Proposed SDD Text Changes on Relay Frame Structure - Clarifications on Open Items of Option 2

IEEE C80216m-08_1107r1.ppt

For discussion and adoption of Option 2 for Relay Frame Structure in 16m SDD

Clarifications on Open Items of Option 2 in Relay Frame Structure

Clarification on “Control signaling”

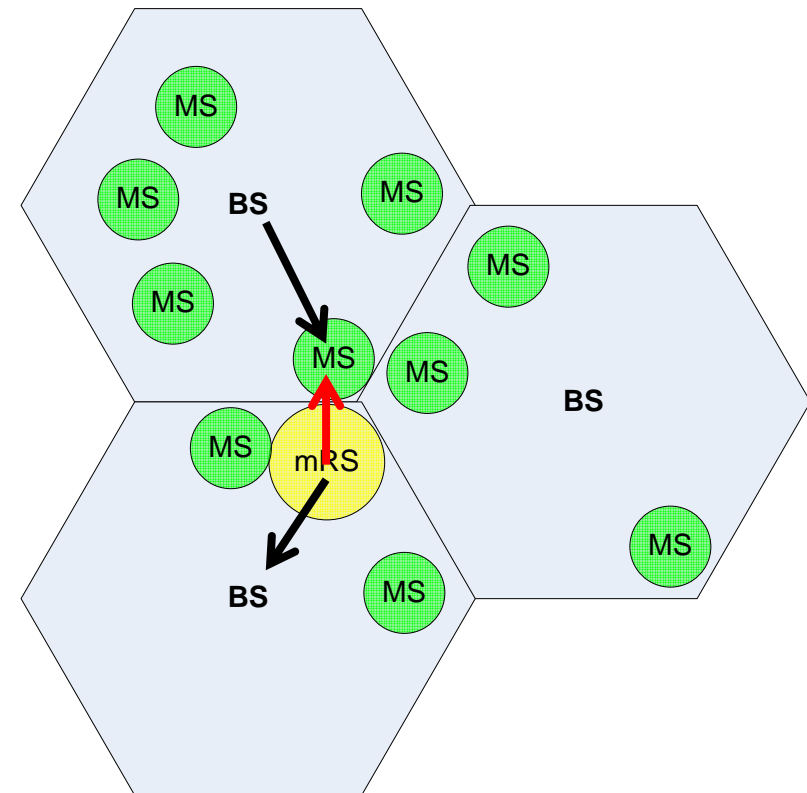
- “coordination” by superordinate node

Clarification on “Interference DL to UL” (2/2)

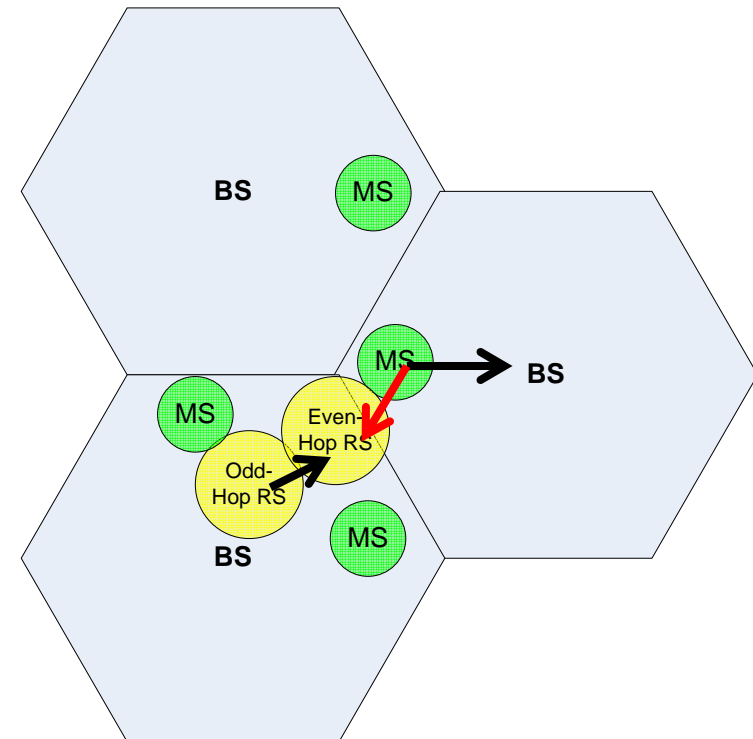
- **Case 2:** Consider a case that the MS is so close to the mRS in the neighboring cell that the interference from the mRS is too strong. In this case, the MS can be attached to the mRS (in the neighboring cell) instead of being attached to the serving BS/RS.
- If mRS2 transmits at a weaker DL pilot power than the serving BS, the MS can be attached to the BS. mRS2 is very close to MS. In this case, the “*MS will transmit at a higher Tx power level so that the mRS2 can hardly listen to another RS*”. This is the same for Option 1, where the only difference is “*MS will transmit at a higher Tx power level so that the mRS2 can hardly listen to another MS*”.
